Title: Cavalon 915 Lower Engine Cowling Heat Protection		
AG-SB-2020-05-B-EN		Compliance Category:
Applicability		A – MANDATORY B – RECOMMENDED C – OPTIONAL
Aircraft type & model: AutoGyro Cavalon	Affected Serial number(s): All Cavalon fitted with the Rotax 915iS engine	
The maintenance manual to be referenced is this stated or subsequent issue.		As per AutoGyro website
This form is the response from AutoGyro GmbH either against a problem found in the product in service requiring a containment or rectification action, or as service information for aircraft modification incorporation. For help, contact AutoGyro on 49(0)5121 88056-00, or email airworthiness@auto-gyro.com.

(Pic. 1)

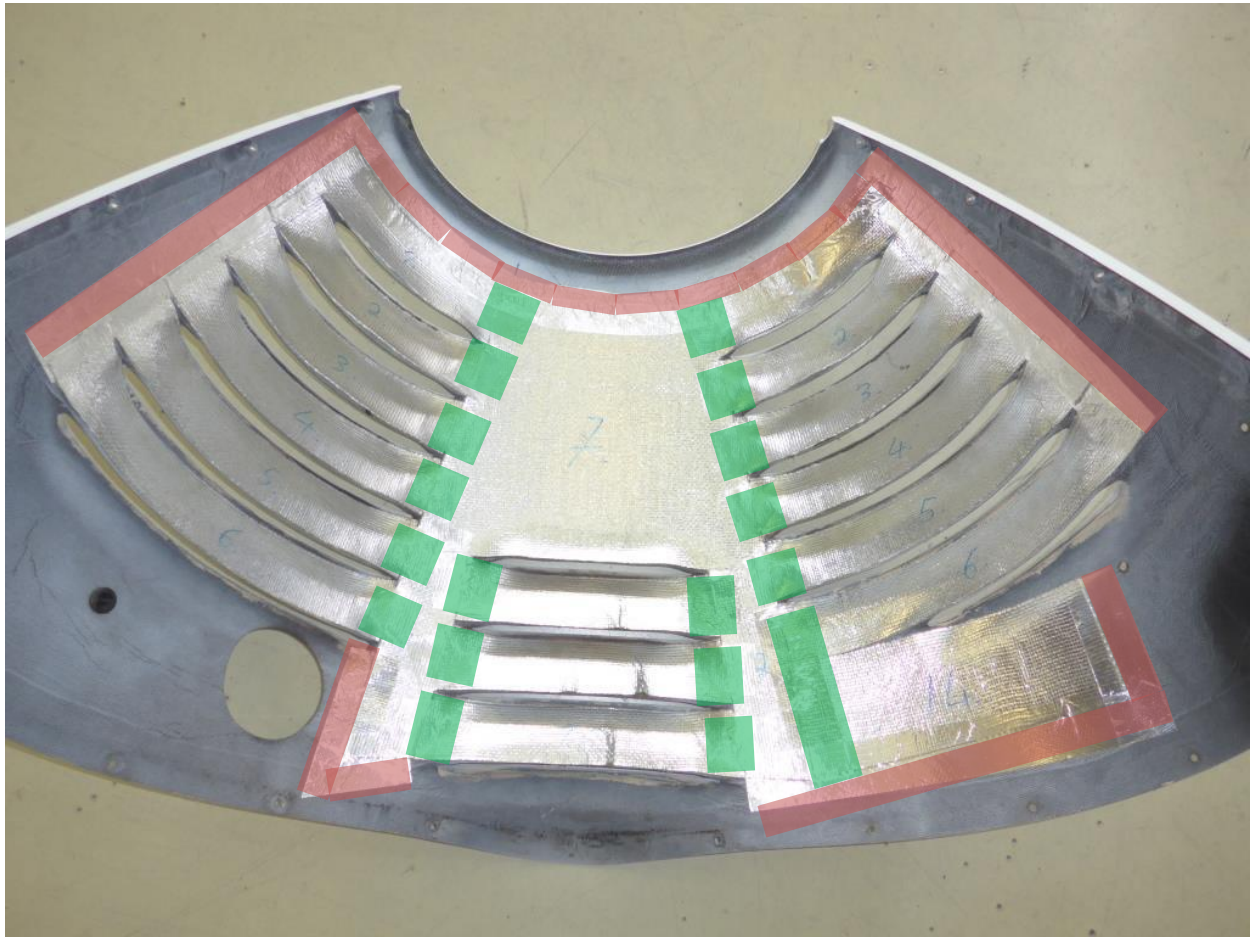
3. De-grease the inside area of the lower engine cowling in the areas where the heat protection is to be applied.
4. Attach the heat protection to the lower engine cowling using Pic. 1 below as a guide.

5. Using an appropriate medium, smooth the area of the interior surface of the cowling where the 50mm alu tape is to be applied (Pic. 2 red areas) and de-grease using silicone remover 34081 or similar. **If this is not carried out, it is extremely likely that the tape will detach from the cowling after a period of time.**

6. Apply the 50mm alu tape to the edges of the 50mm alu tape at both the previously smoothed areas (red areas) and the green areas shown in pic 2.
7. Re-fit the lower and upper engine cowlings.
